ALLEGHENY COUNTY SANITARY AUTHORITY

CONTRACT NO. 1729 G, E, H, P

EAST HEADWORKS

ADDENDUM NO. 10

420-M-13
HEADWORKS ODOR CONTROL FACILITY
CHEMICAL BUILDING PLAN

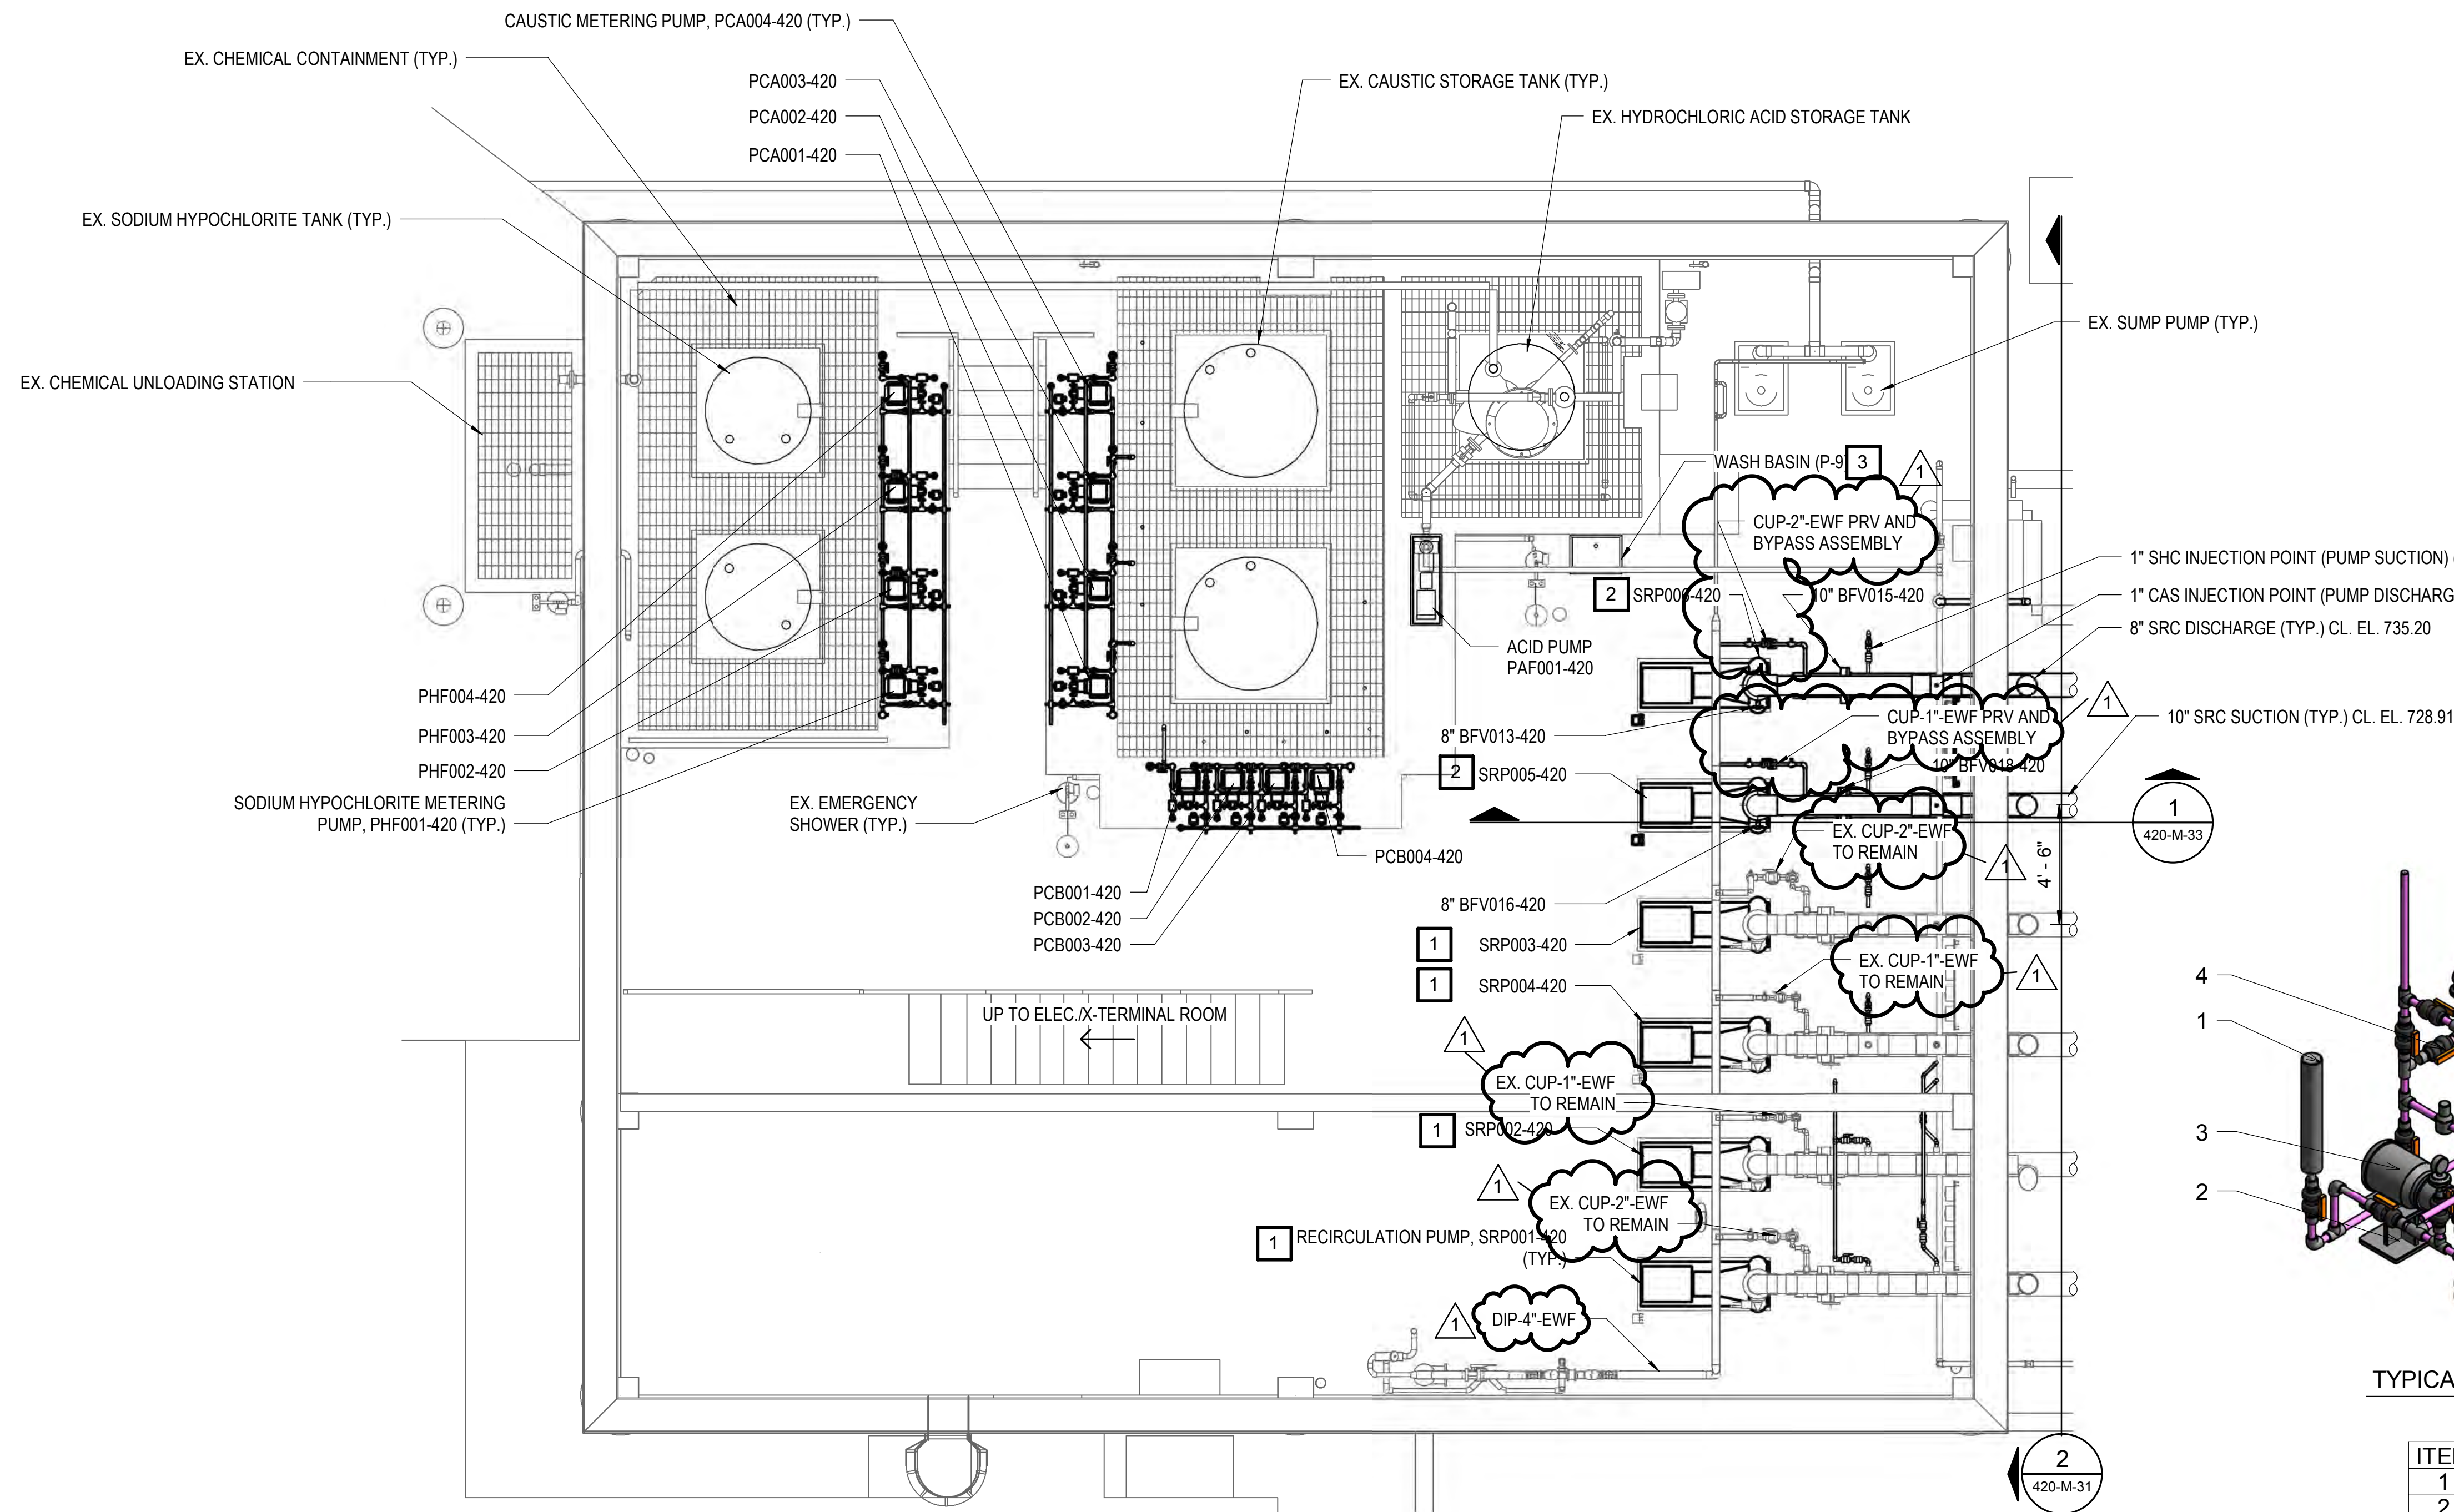
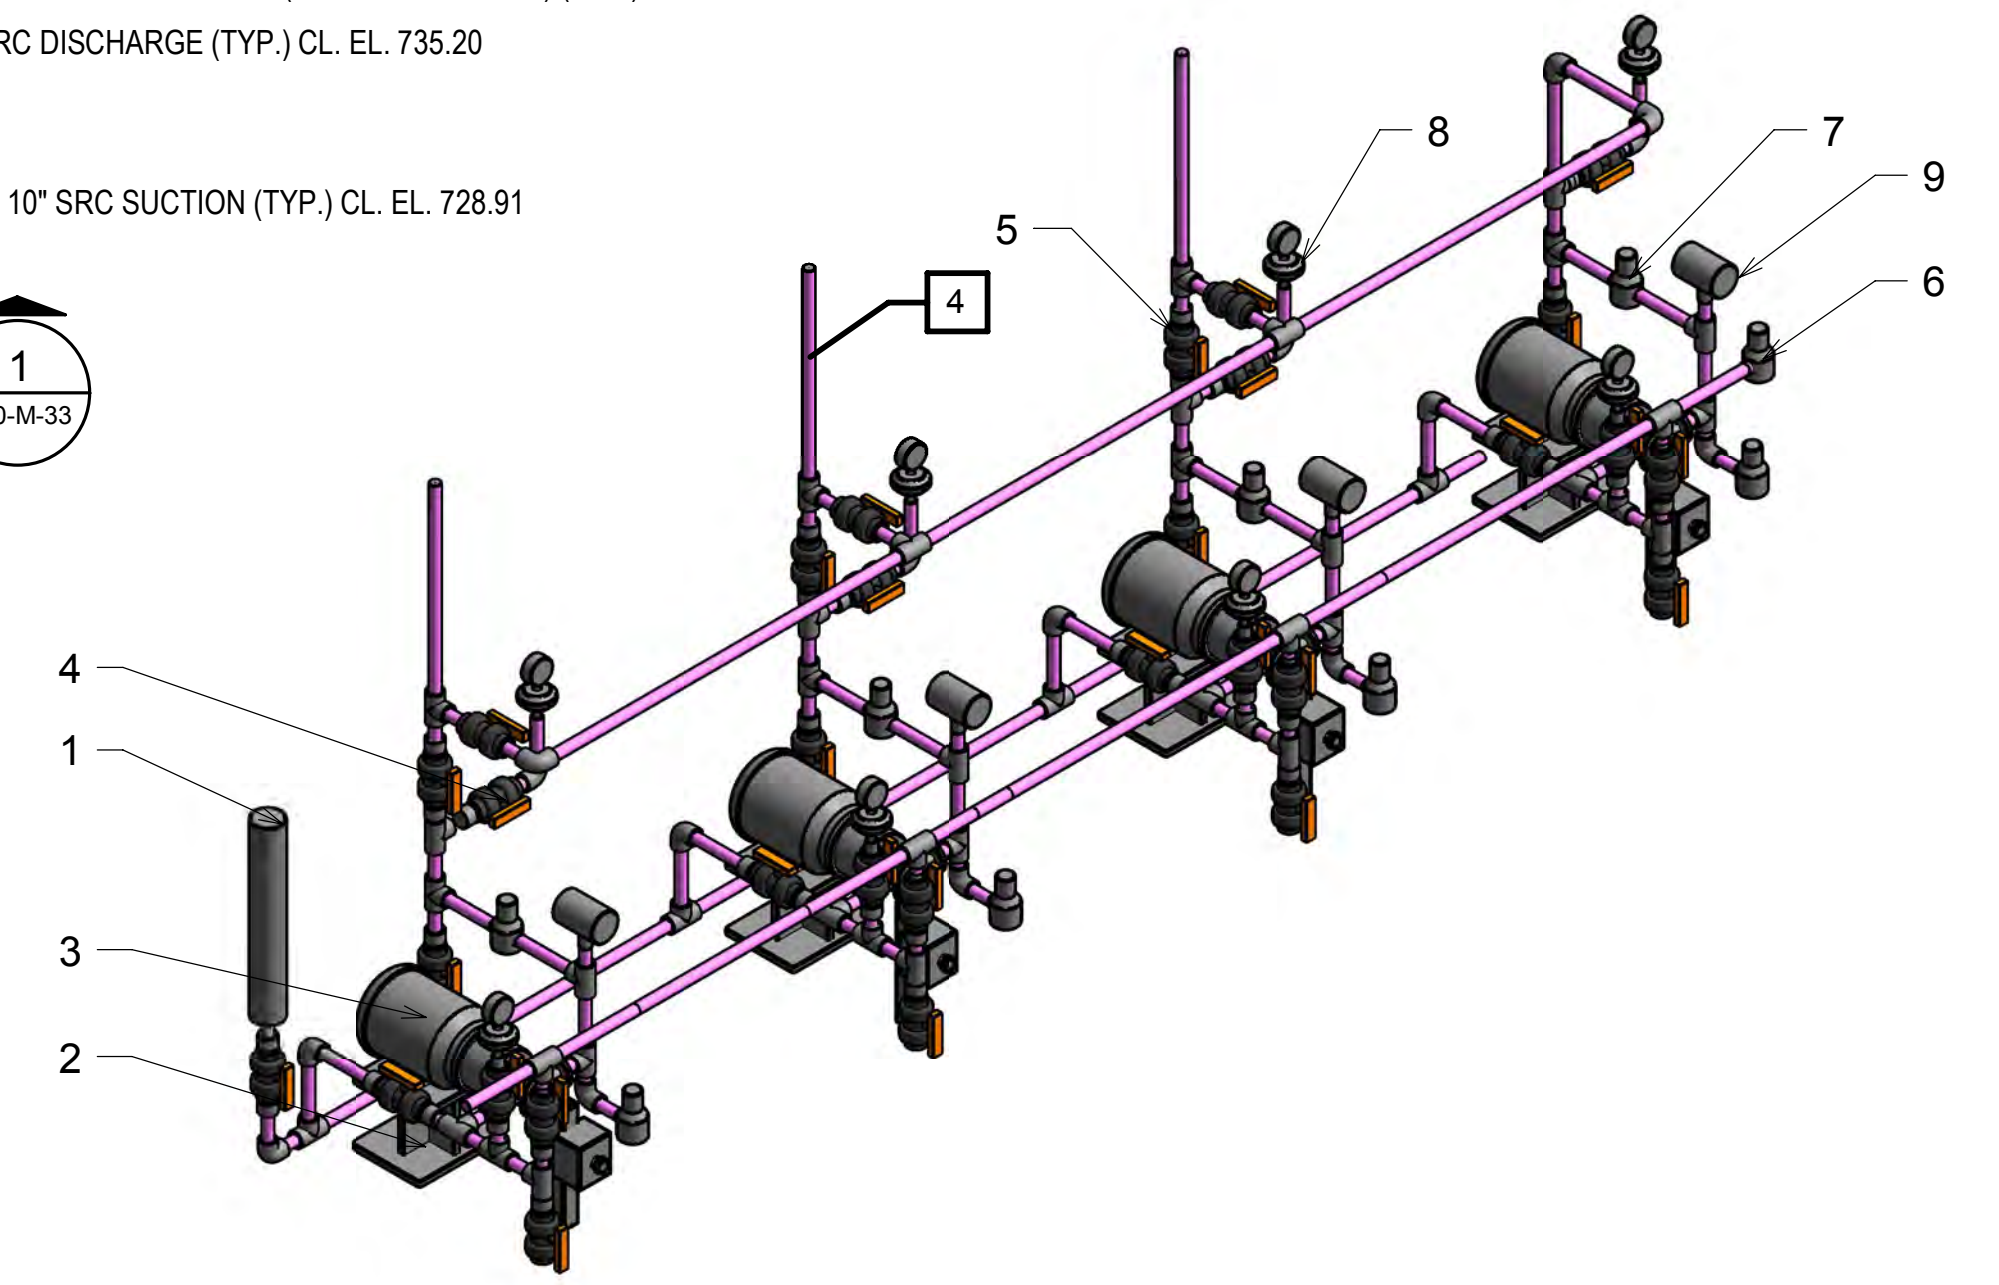
217. **QUESTION:** Reference drawing 420-M-01 (305 of 645) which shows lines CUP-2"-EWF & CUP-1"-EWF going from 2 locations on DIP-4"-EWF to 2 locations on CVP-8"-SRC. Please clarify where the DIP-4"-EWF is to be tapped, where the pressure reducing valves & by-pass assemblies are to be installed, and where the CUP-2"-EWF & CUP-1"-EWF lines tie into the CVP-8"-SRC lines.

RESPONSE: See updates to Drawing 420-M-13 included with this addendum.
